CITY OF NOVI CITY COUNCIL
JUNE 17, 2024

SUBJECT: Consideration of the request of E & M Holdings, LLC, (Society Hill) to amend the 2001 Consent Judgment, and to set a public hearing on the proposed development.

The City's staff and consultants reviewed the latest proposal and provided written comments to the applicant on May 2nd. Since that time, staff has met with the applicant and discussed many of the issues raised in the review letters. As a result of that discussion, and additional information provided by the applicant, staff has taken the opportunity to revise and update the initial review letters, as follows:

PROJECT NAME: SOCIETY	PART OF THE SE 1 T.1N., R.6E., CITY 6	SHEET TITLE: OFF-SITED
---------------------------------	--	----------------------------------

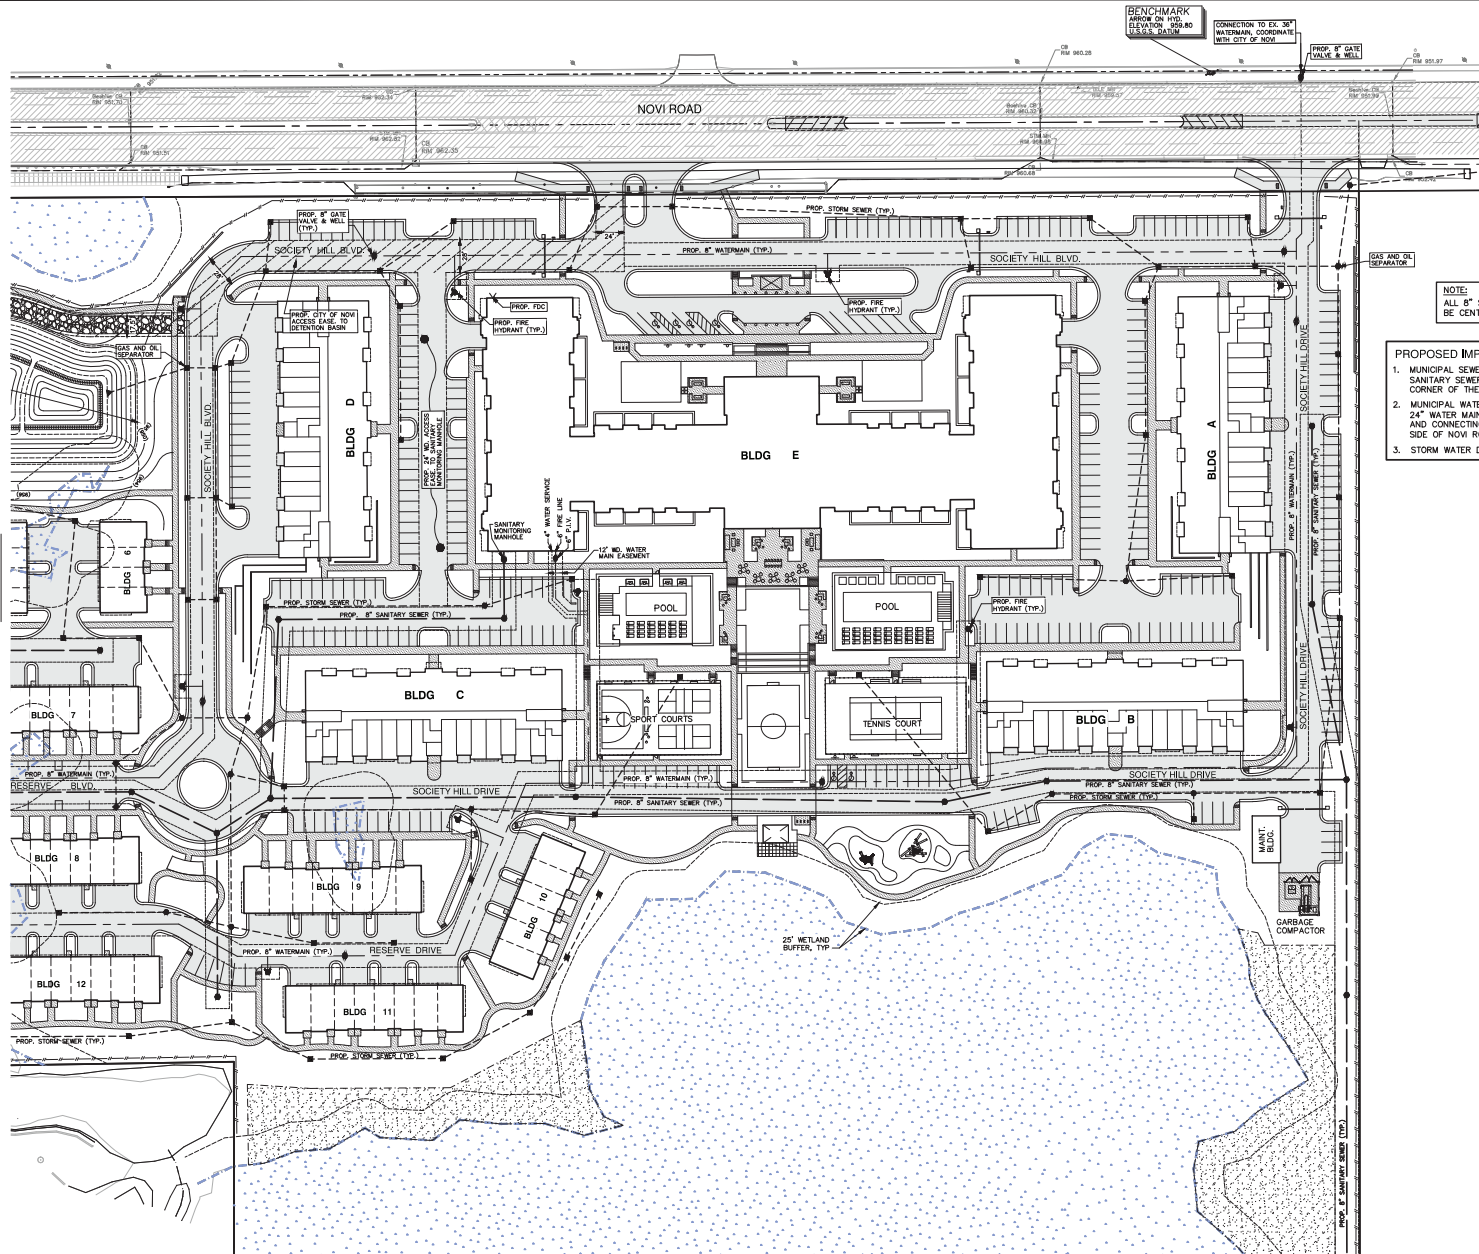
2. A soil boring will be provided for the off-site detention basin prior to Final Site Plan Approval. Referring to Sheet 9 of the Preliminary Site Plan submittal, the elevation of the wetlands adjacent to the off-site detention basin is appx. EL. 941.50 and the Low Water Elevation of the off-site detention basin is set at EL 942.0 (0.5’ higher than the wetland elevation. Although the groundwater elevation at the detention basin is expected to be near the wetland elevation of 941.50 (just below existing grade), the Low Water

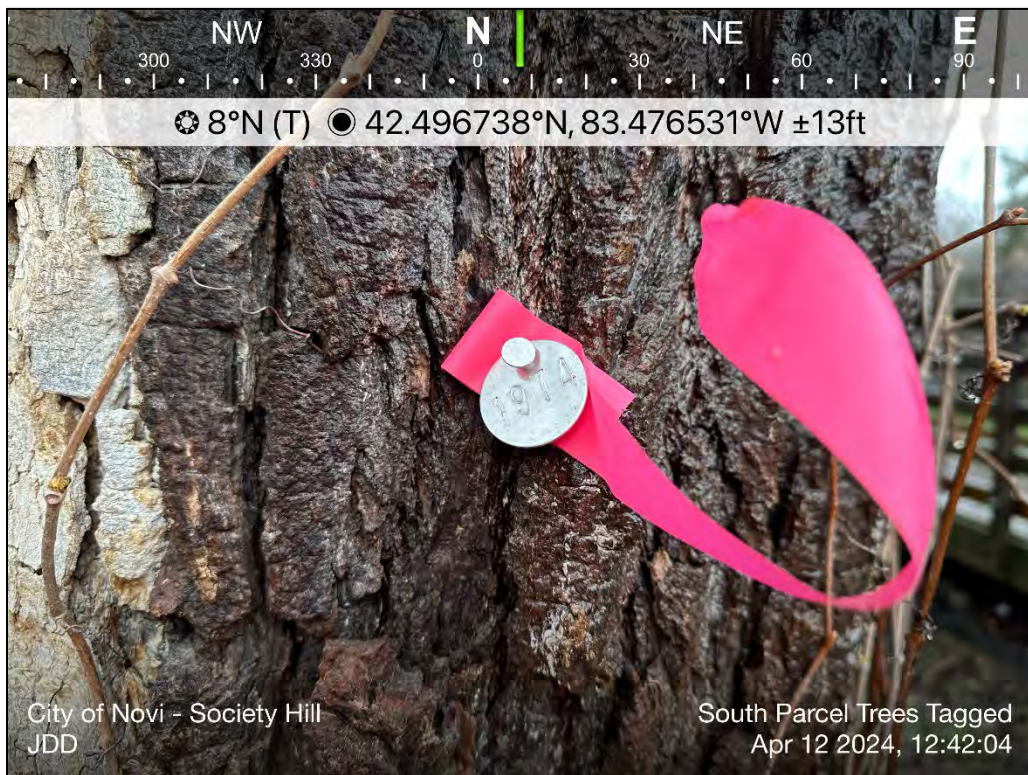
Overview of the potential missed vernal pool identified in **Attachment B**. Also identified in the comments as Potential Missed Wetland 2.

Overview of the potential missed wetland in **Attachment B**. Also identified in the comments as Potential Missed Wetland 1.

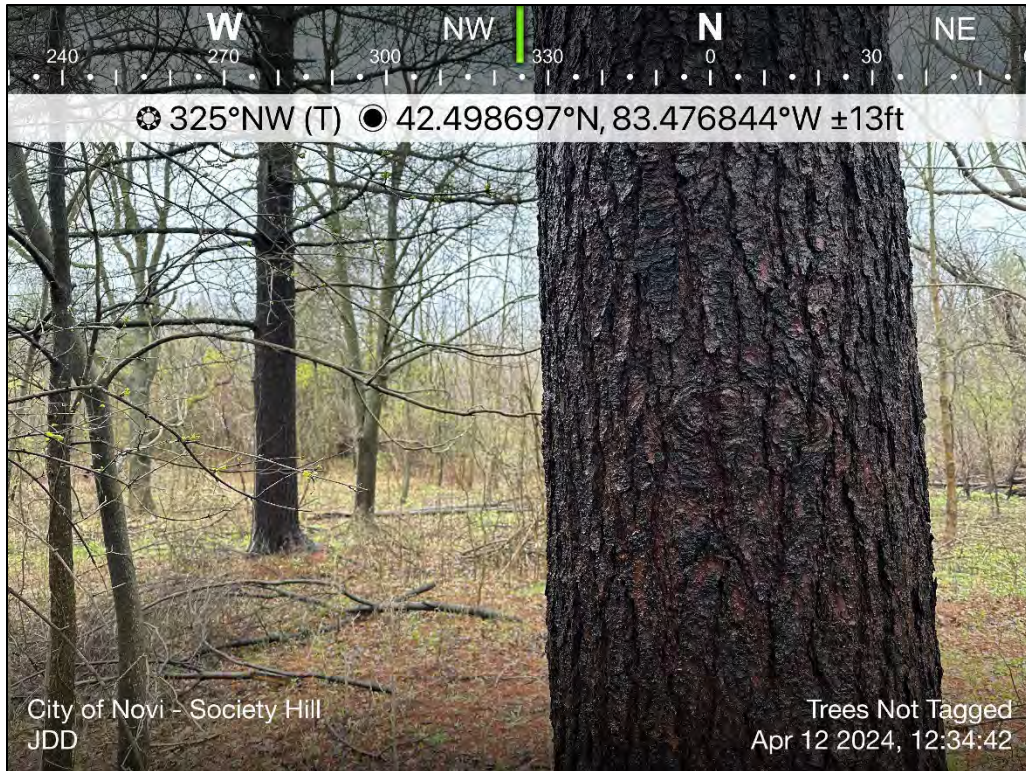
Overview of a tree tag that does not match the survey. This tree is approximately located around Tree 679 identified in the PSP. Tree tag reads as 4339.

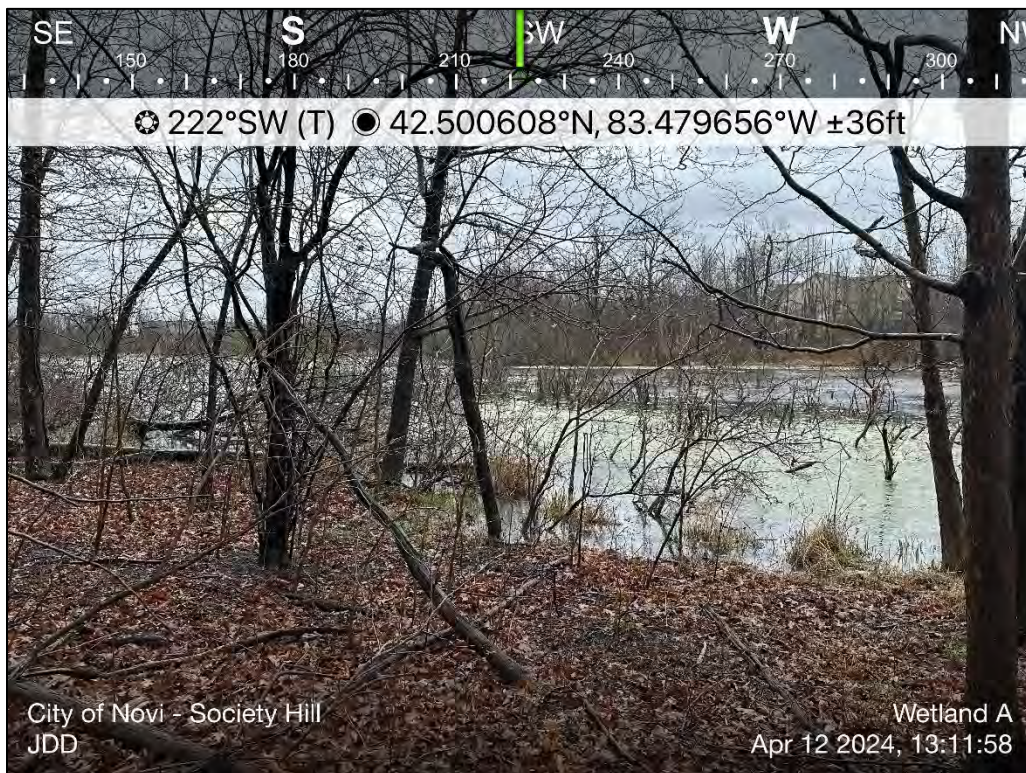
Overview of a tree tag that does not match the survey. This tree is approximately located around Tree 1104 identified in the PSP. Tree tag reads as 4367.

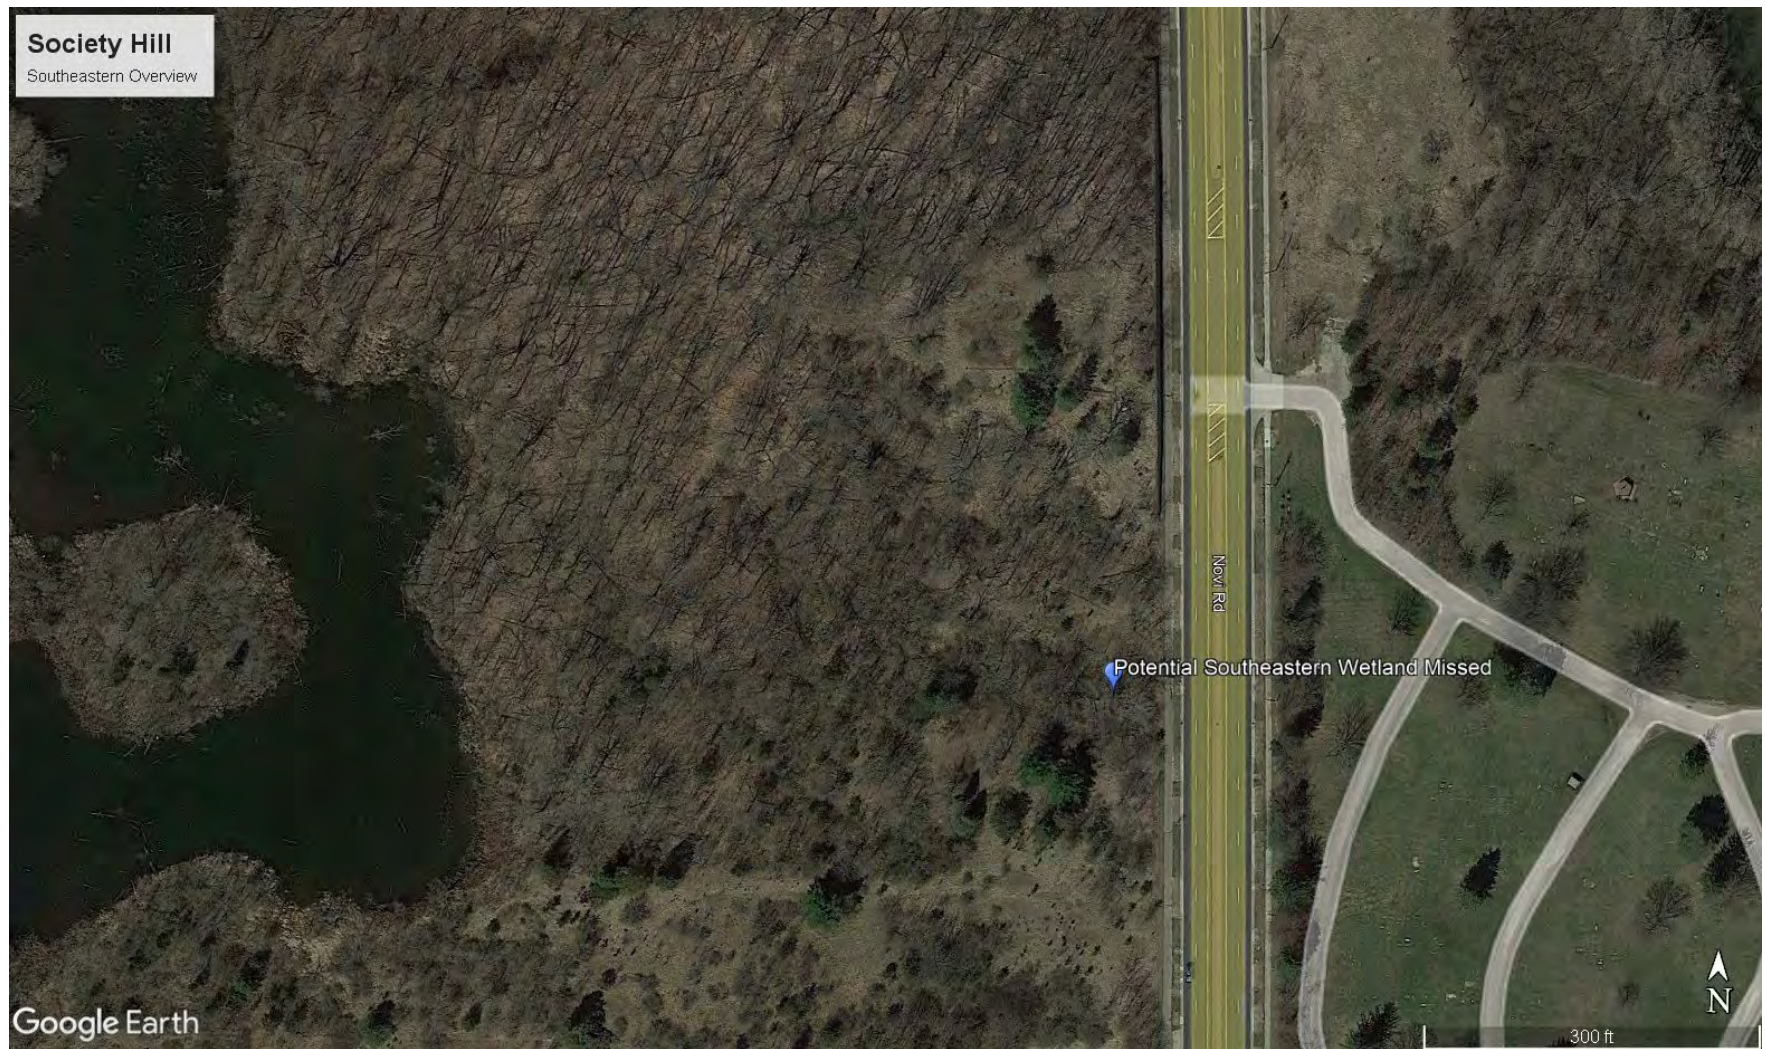
Overview of the northern portion of the site with potentially missed wetlands. Photographs of each area are included in **Attachment A**.

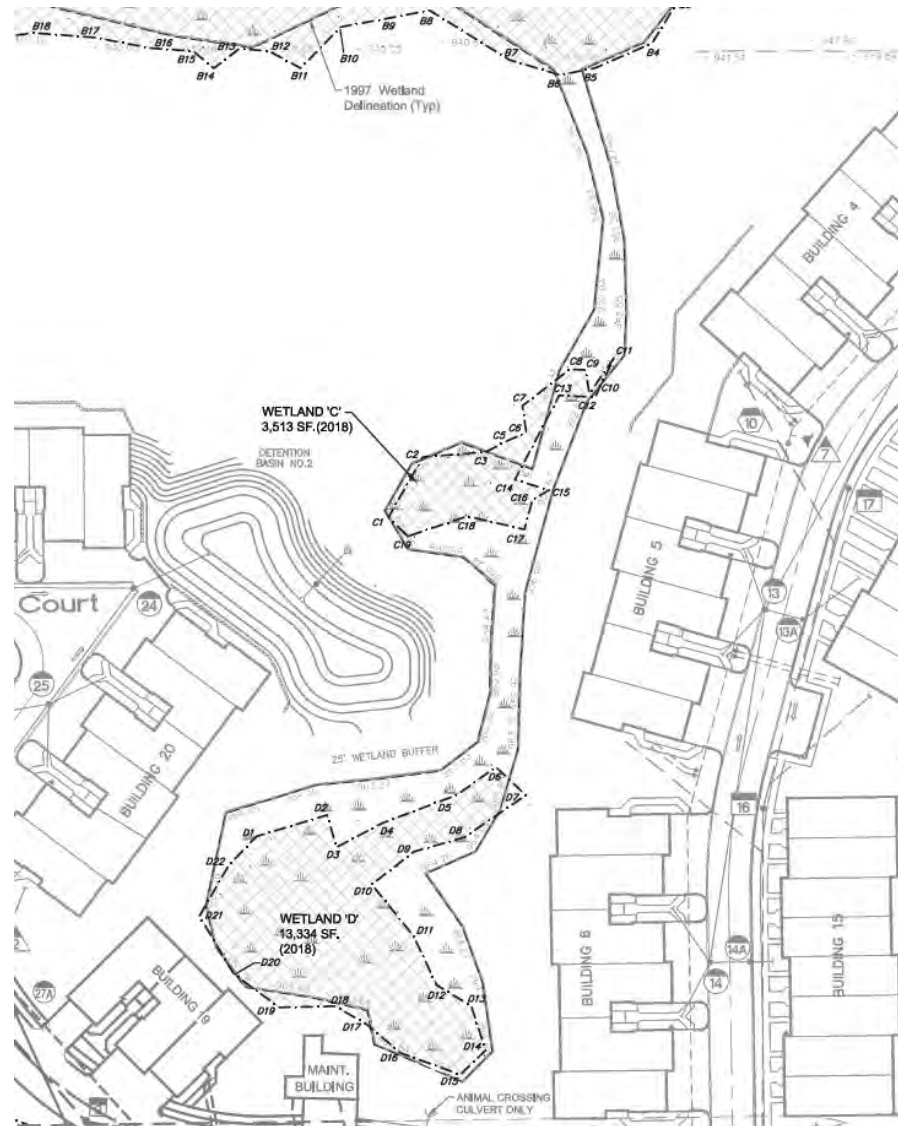
Overview of the southeastern portion of the northern parcel with a potentially missed wetland. Photographs of the area are included in **Attachment A**.
